DEPARTMENT OF NATURAL RESOURCES

Division of Water Rights

RE: Response to Comments

The Utah Division of Water Rights (DWRi) appreciates the public's engagement and feedback regarding the development of groundwater management plan for Sand Hollow Area in Washington County. In response to the January 14, 2025 public meeting on developing a groundwater management plan for this area, DWRi received 4 comments.¹ The following summaries and responses address questions and concerns raised by commenters.

Figure 1. Comparison of USGS study area boundary (red) and proposed management boundary (black).

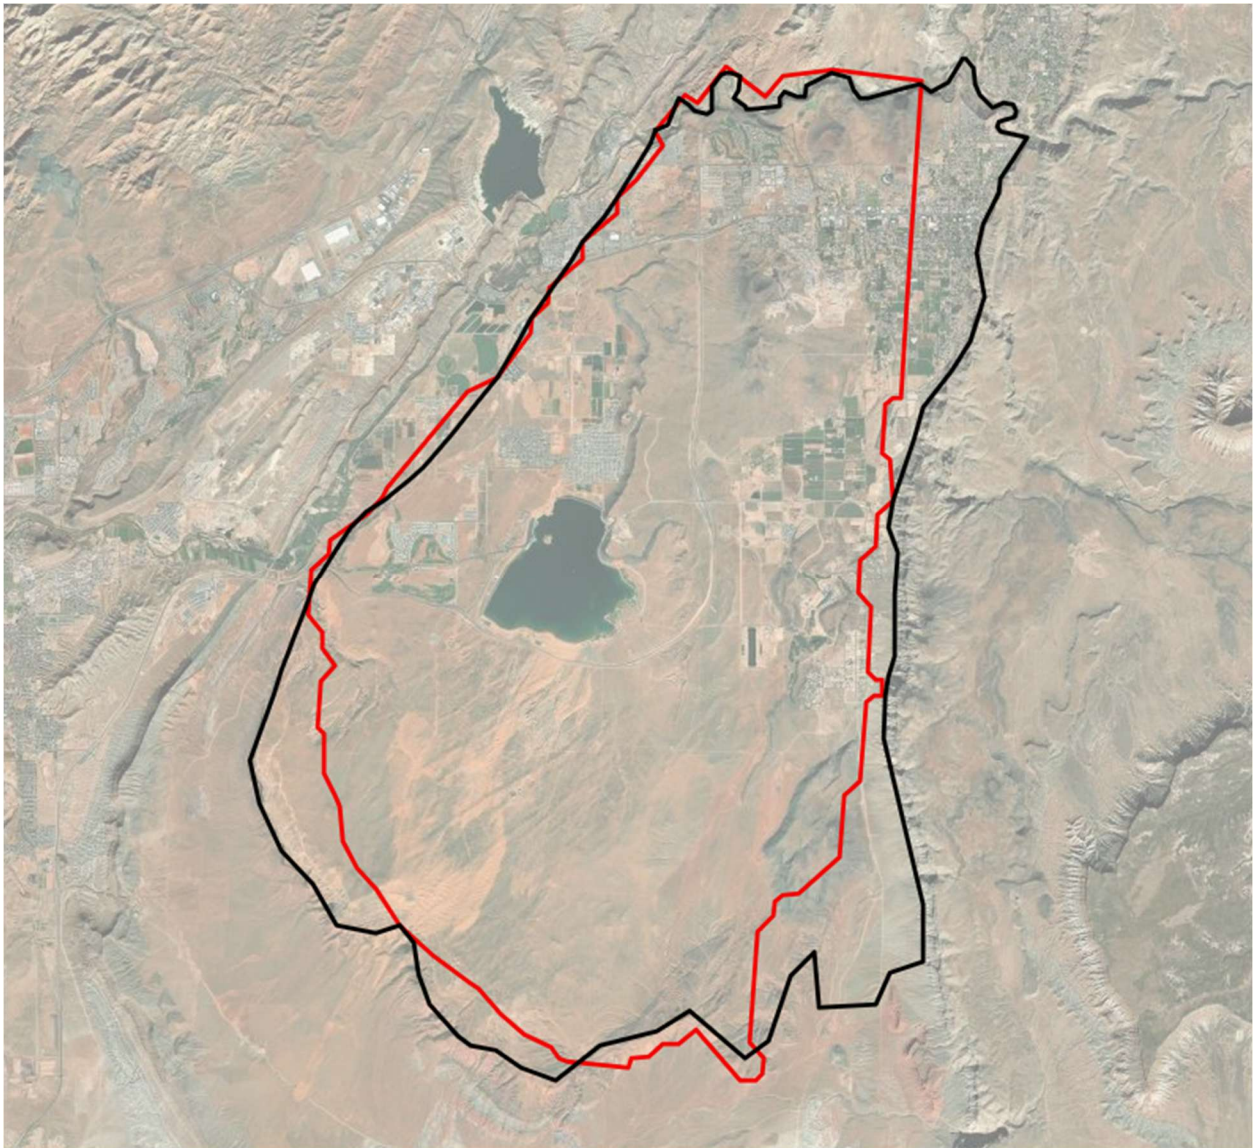
There is significant concern regarding the fundamental understanding of the Sand Hollow aquifer system, emphasizing the need for a holistic understanding of its hydrogeology. They question the study area's boundaries, probing the rationale behind its western and southern limits and the exclusion of specific areas, while also seeking clarification on the distinction between the Bench basin and the lower area. A central theme is the accurate delineation of the aquifer's physical extent, with inquiries into the role of springs along the Virgin River and the influence of geological formations like the Kayenta and Silver Reef formations on potential water loss. The committee stresses the importance of thoroughly understanding how water enters, moves through, and exits the system, investigating the roles of faults, fissures, caliche, and gypsum in recharge processes, the impact of volcanic flow on water movement, and the significance of recharge from sources like percolation from the north and flow from the Pine Valley and Kolob mountains. (In response, see [3].)

Aquifer System Boundaries: The study area boundary shown in Figure 1 of USGS Scientific Investigations Report 2012-5236 is not a precise delineation of the aquifer extents intended or suited for management purposes. For the purposes of the groundwater management plan, the state engineer anticipates the following boundaries will be used:

- The eastern boundary extends to the Hurricane Cliffs.
- The northern boundary follows the Virgin River.
- The southern boundary will follow the edge of the Navajo Sandstone outcrop. Aside from wells in Warner Valley, there are no approved or perfected wells near this boundary.
- The northwestern boundary follows the location of a topographic high that corresponds to the extent of the Navajo Sandstone. This topographic high is pronounced in the south but less so towards the north. Water level data in well (C-42-14)15cbd-1 (around 3,000 feet west of this boundary) shows steady water levels at around 90 feet below land surface. In contrast, water level data in well (C-42-14)15dad-1 (around 2,000 ft east of this boundary) show water levels rising 30 feet from 1998 to 2018.
